**Bureau of Development Services - Land Use Services Division**  
**Refund Request Form for Void/Withdrawn/Cancelled Application/Case/Appointments**

## Design Review Project Narrative 1549 SE Ladd Ave.

File No. LU 17-280914 HR

PLAN CHECK: LU 17-280914 HR  
1549 SE LADD AVE

LN 17-280914HR

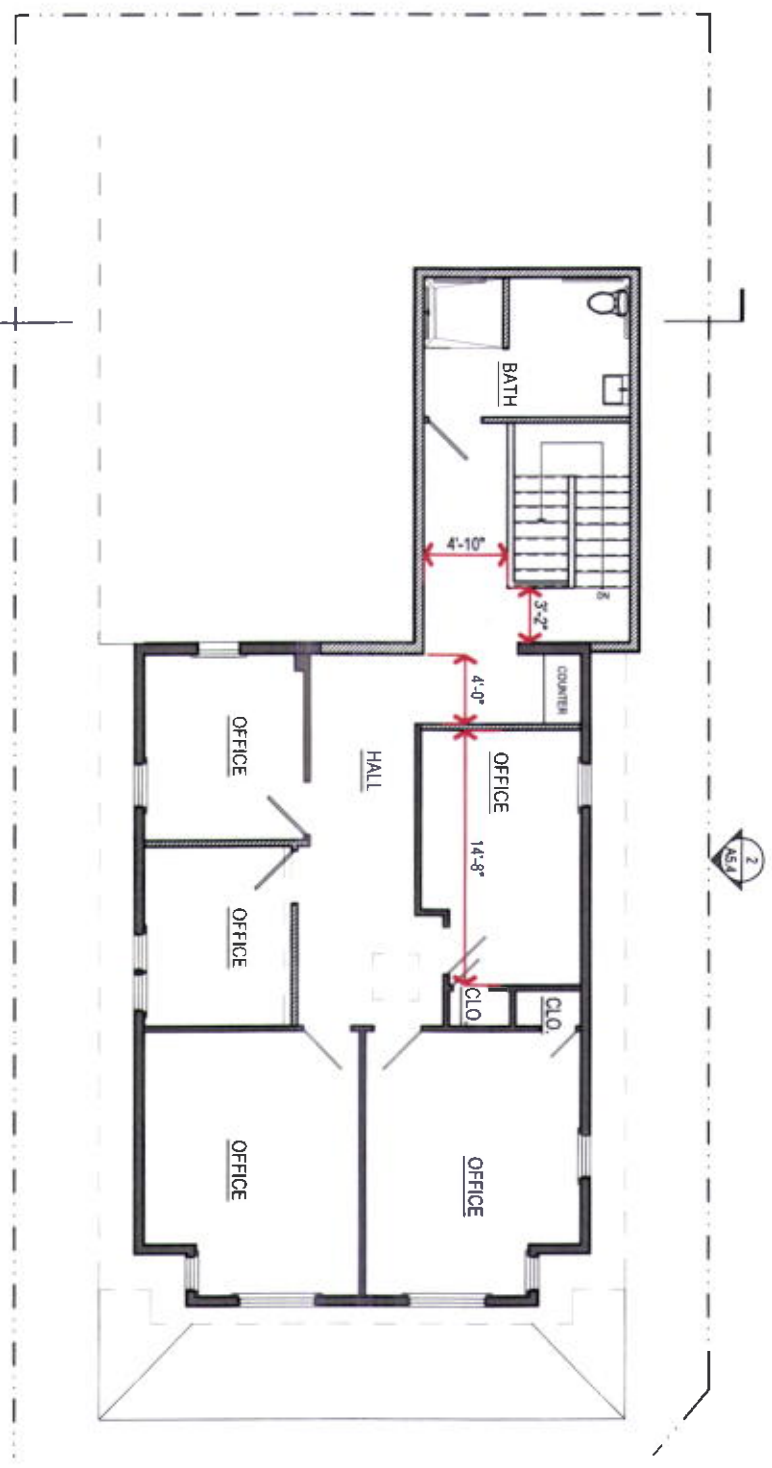
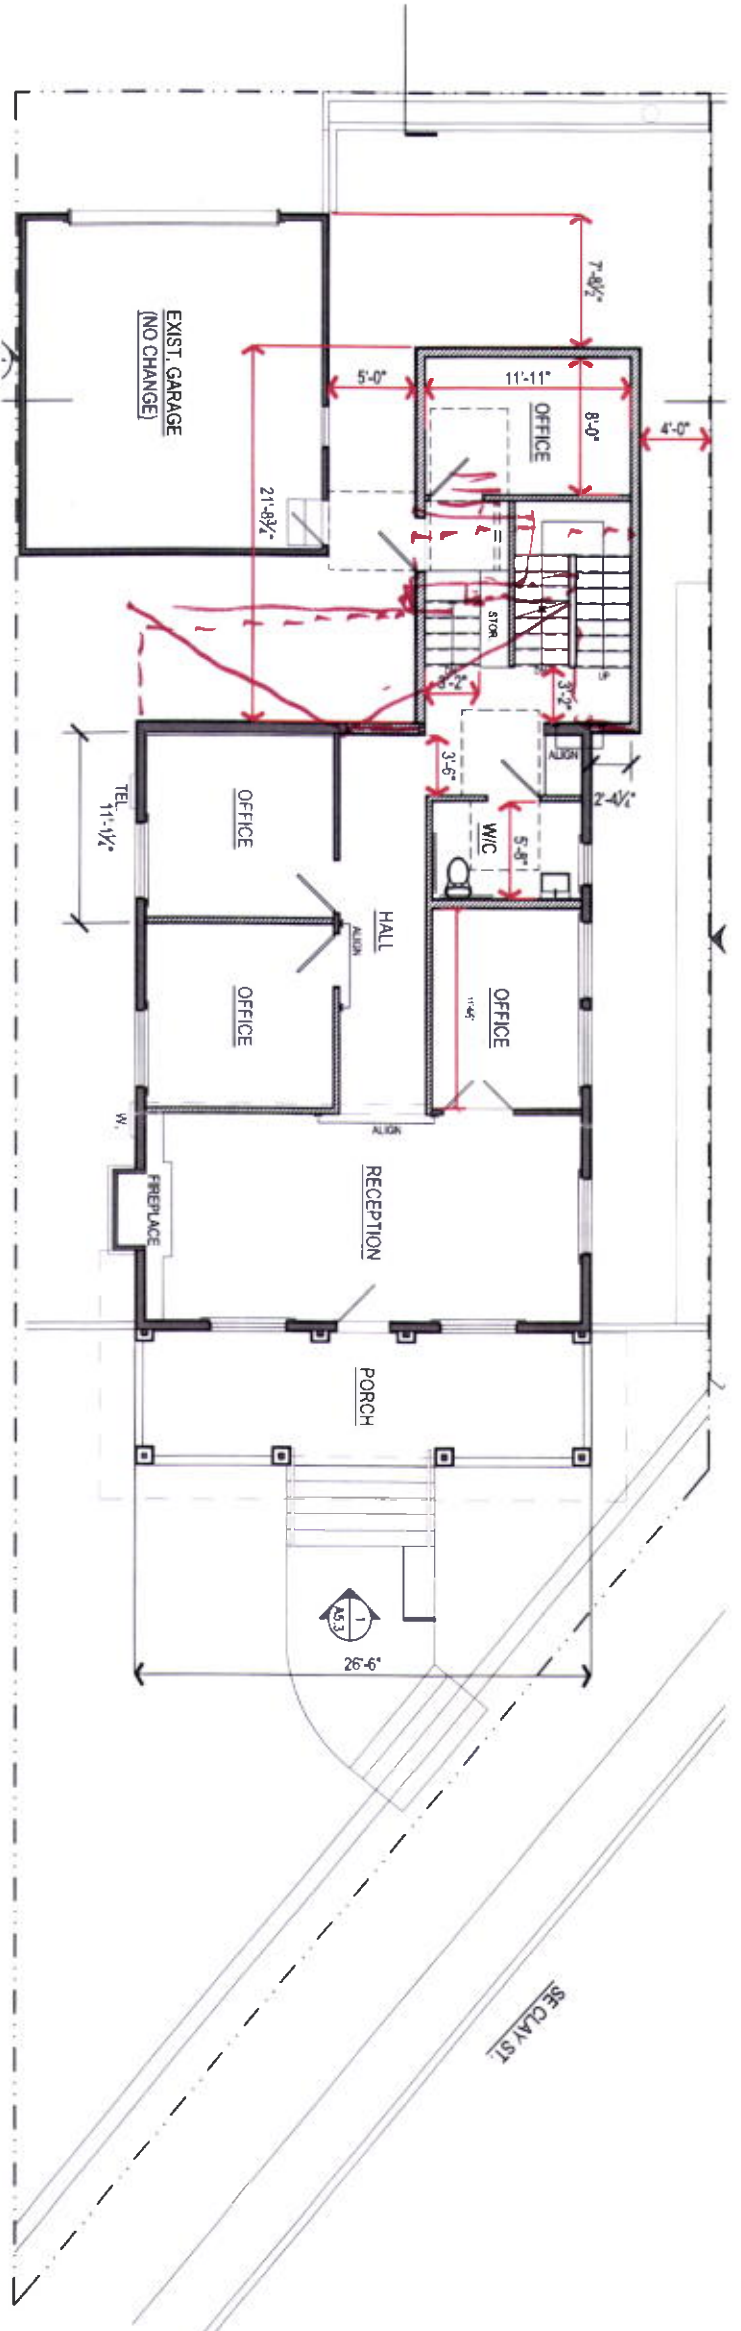
IF YOU ATTACH TO THE GARAGE, YOU WOULD HAVE TO MEET SETBACK REQUIREMENTS FOR THE ENTIRE RH FACING FACADE.

**Figure 1: Subflooring in conventional construction**

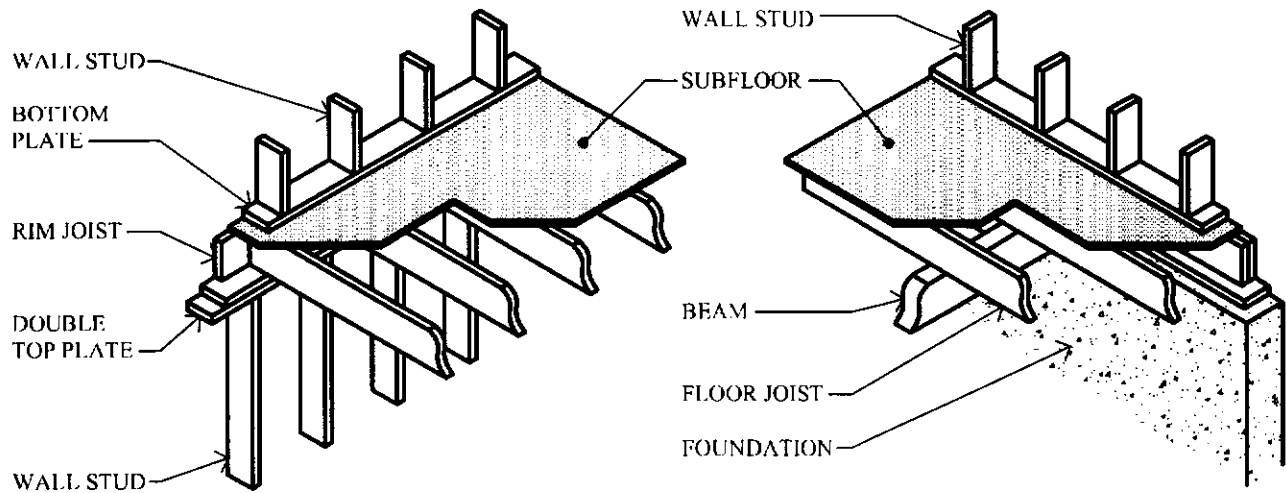
50% ~~WALLS~~ \*ART CASE
